**COMMISSION OF ARCHITECTURAL REVIEW  
STAFF REPORT  
November 28, 2017, Meeting**

10. **COA-025771-2017** (H. Kellman) **3116-3118 East Marshall Street  
Chimborazo Park Old and Historic District**

**Project Description:** **Construct two duplexes.**

1925 Sanborn Map of the 3100 Block of E. Marshall St.

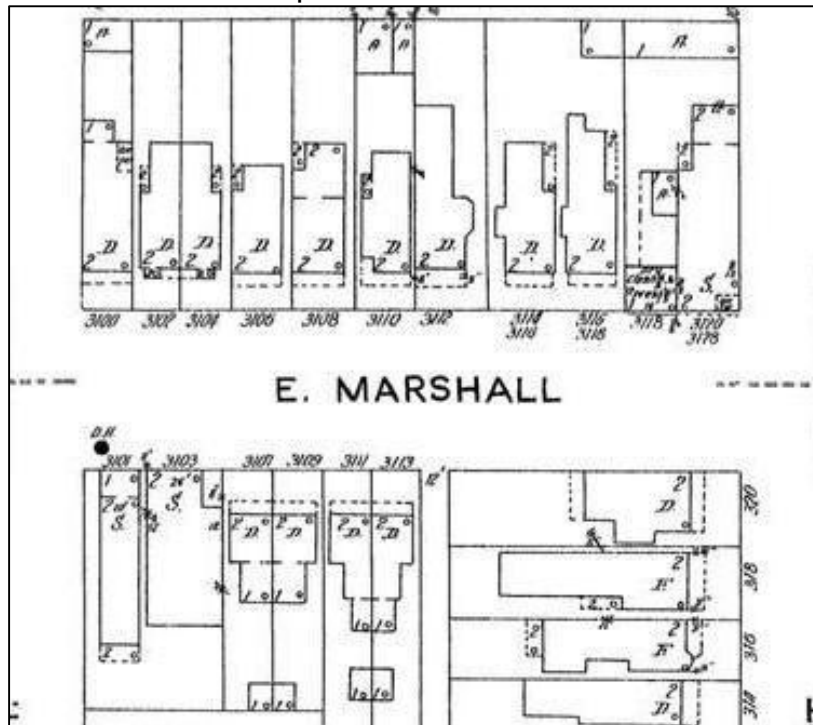
The historical setback pattern is consistent with the existing pattern with the commercial structures sitting proud of the residential structures. The proposed setback is not consistent with the historical pattern for the block.
